B. DRAWINGS

Substitute formal drawings are submitted herewith. The drawings will be submitted separately to the Official Draftsman upon approval of the Examiner in this case.

Fig. 4.

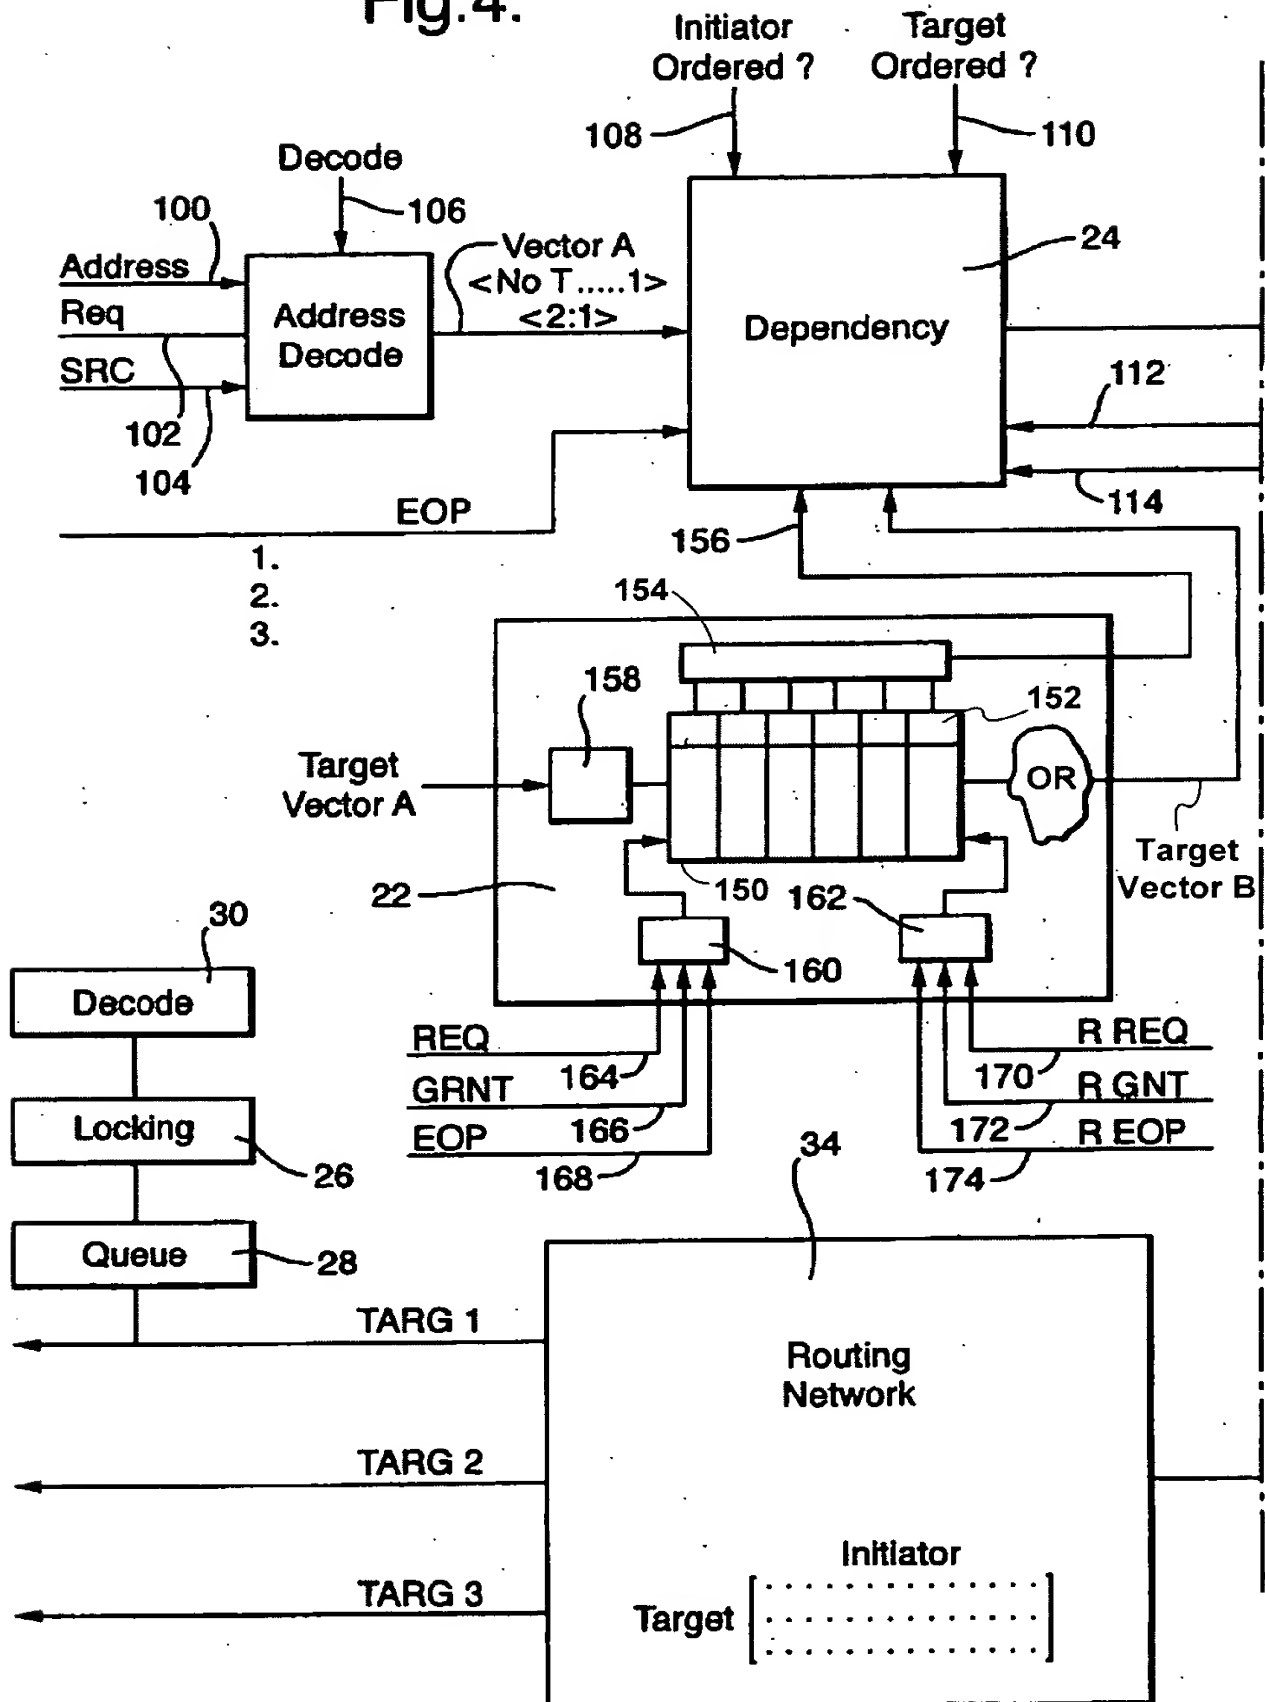
Figure 4 is amended to label elements 150, 152, 154, an "OR" logic element and "Target Vector B" to be consistent with the specification as filed. Fig. 4(cont) is corrected to label element 25, to correctly draw a line between element 184 and the signal line labeled 190, and to correctly label "Resource vector D" so as to correspond to the description in the specification. Fig. 5 is amended to correctly label elements 28 and 30 to be consistent with the specification. No new matter is added by these corrections to the drawings.
